ACCESSION NBR:9510160115 DOC.DATE: 95/10/06 NOTARIZED: YES DOCKET #
FACIL:50-305 Kewaunee Nuclear Power Plant, Wisconsin Public Servic 05000305

SUBJECT: Application for amend to license DPR-43, redefining pressure boundary for Westinghouse hybrid expansion joint sleeves.

Docket 50-305
Operating License DPR-43
Kewaunee Nuclear Power Plant
Proposed Amendment 136 to the Kewaunee Nuclear Power Plant Technical Specifications to Redefine the Pressure Boundary for Westinghouse Hybrid Expansion Joint Sleeves

FIGURE 1

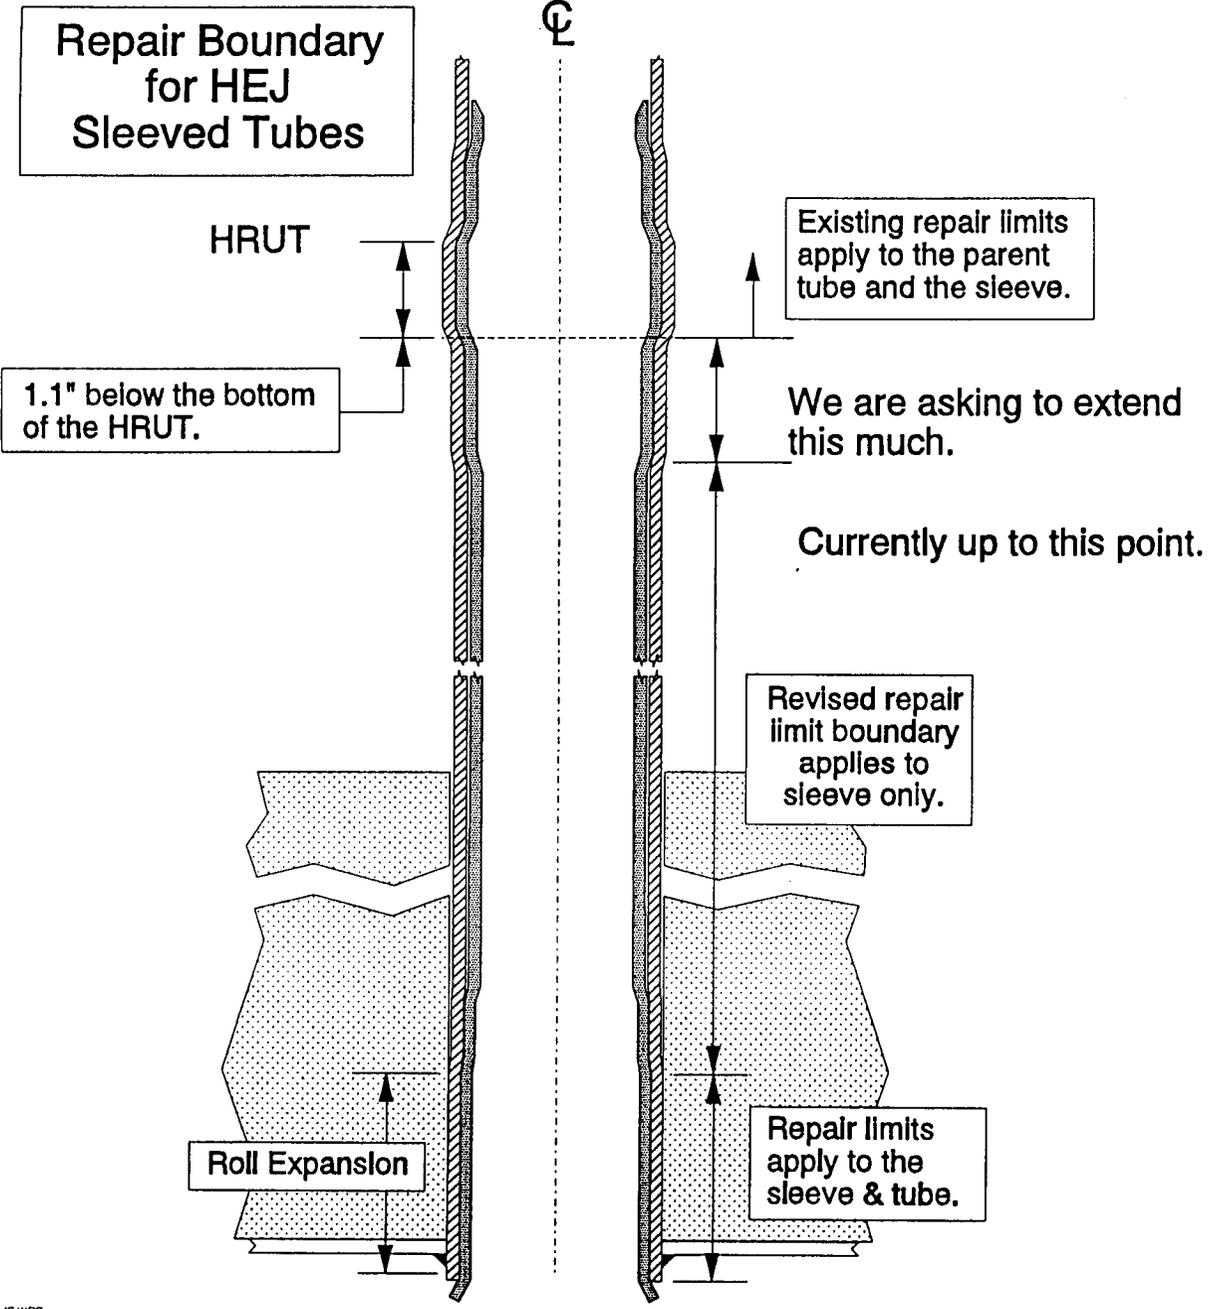
The proposed revision to the upper HEJ pressure boundary, as shown on Figure 1, will allow PTIs located in the upper HEJ to remain in service provided there is adequate structural and leakage integrity relative to the guidance of Regulatory Guide I.121. The proposed pressure boundary is based on analytical evaluations, the results of prototypic testing, and the results of destructive examinations and tests of HEJ specimens removed from the Kewaunee SGs in April of 1995. The culmination of these test results shows that tubes with PTIs located 1.1 inches or farther below the bottom of the hardroll upper transition (HRUT) have sufficient structural and leakage integrity and do not compromise the safety of the SG tube bundle.

The purpose of this proposed amendment request is to redefine the pressure boundary for the upper sleeve-to-tube joint in HEJ sleeved tubes at the KNPP. The proposed TS change and technical basis are the same as that proposed by AEP. The proposed pressure boundary is shown on Figure 1. The proposed pressure boundary will allow PTIs located 1.1 inches below the HRUT and lower, with an added uncertainty factor to account for NDE measurement and variations in the physical dimension of the hardroll joint, to remain in service. This uncertainty factor will be established based on the NDE technique selected to perform the HEJ inspection.

This proposed amendment request will modify KNPP TS Section 4.2 and Figure TS 4.2-1 to redefine the pressure boundary for the upper HEJ sleeve joint. The proposed repair boundary is based on analytical evaluations, the results of prototypic testing, and the results of destructive examinations and tests of HEJ specimens removed from the KNPP SGs. The culmination of these test results show that tubes with PTIs located 1.1 inches below the bottom of the HRUT and lower have sufficient structural and leakage integrity, and do not compromise the safety of the SG tube bundle. The proposed changes are as follows:

- 2) Figure TS 4.2-1 will be revised to indicate the upper HEJ pressure boundary and repair limits.
- 3) The basis for TS Section 4.2 will be modified to discuss the revised pressure boundary and the number of tubes that can be left in service based on the application of the SLB leak limit for the faulted loop. This leak rate value also includes primary-to-secondary leakage contribution from tubes left in service due to application of the voltage-based plugging criteria for tube support plate intersections.

- HEJ sleeved tubes with circumferential indications located from 1.1 inches to 1.3 inches (not including measurement uncertainty) below the bottom of the hardroll upper transition may remain in service provided the faulted loop steam line break (SLB) projected leakage limit from all sources is not exceeded. A SLB leakage limit of 0.033 gpm shall be assumed for each indication regardless of actual length or depth.

- HEJ sleeved tubes with circumferential and/or axial indications whose upper most extent is located greater than 1.3 inches below the bottom of the hardroll upper transition may remain in service.

- HEJ sleeved tubes with axial indications whose upper most extent is located less than or equal to 1.3 inches below the bottom of the hardroll upper transition shall be plugged.
